**EPA Superfund
Record of Decision:**

**LEHIGH VALLEY RAILROAD
EPA ID: NYD986950251
OU 01
LE ROY, NY
07/27/1999**

Record of Decision
Lehigh Valley Railroad Derailment Site
Town of LeRoy, Genesee County
Site Number 8-19-014

TOWN OF LEROY	GENESEE COUNTY, N.Y.
PROJECT NO. 35090.200	DWG. NO. 35090-29
SCALE: 1"=2000'	DATE: 10/27/95
	FIGURE NO. 2

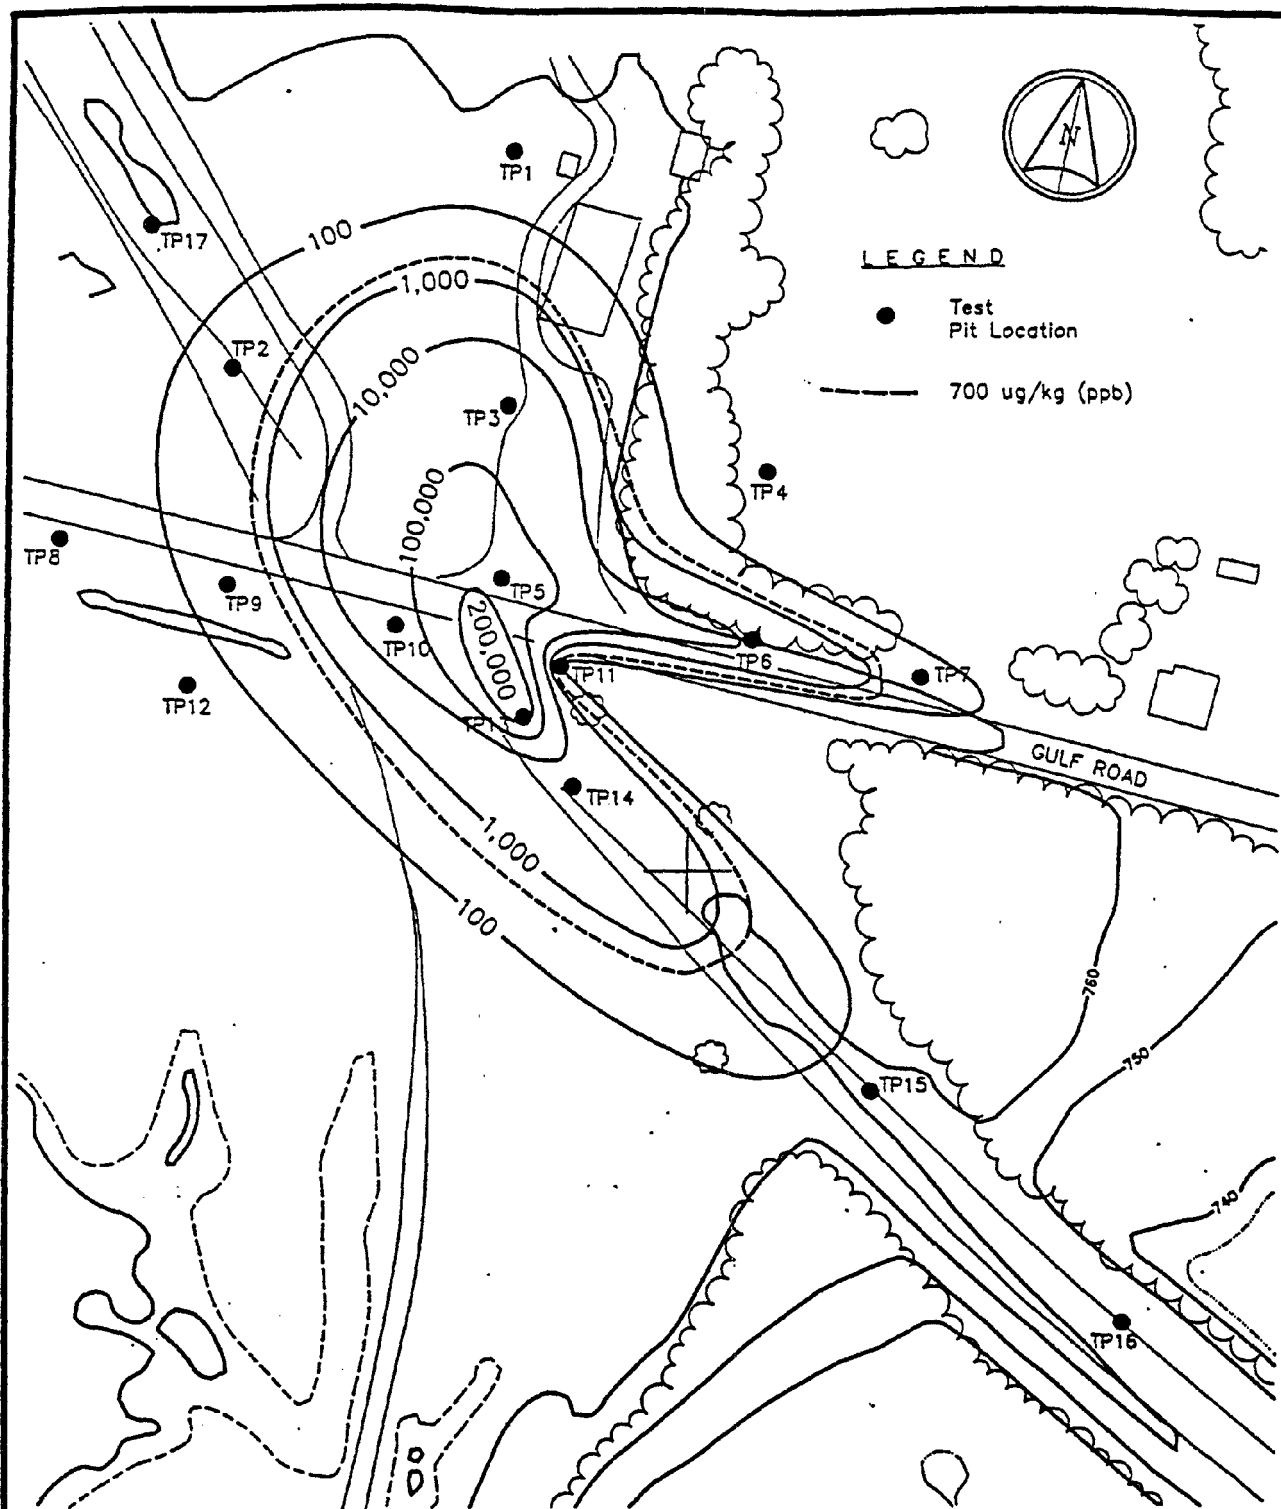
L.18: The RI indicates that "...the eastern boundary of the contaminated plume has not been defined" However, Figure 2 indicates that 14 wells are contaminated along Spring Street but none east of Spring Street. "Does this mean that the eastern flow of the plume has stabilized or that DEC does not know due to the lack of monitoring wells to the east of Spring Creek"?
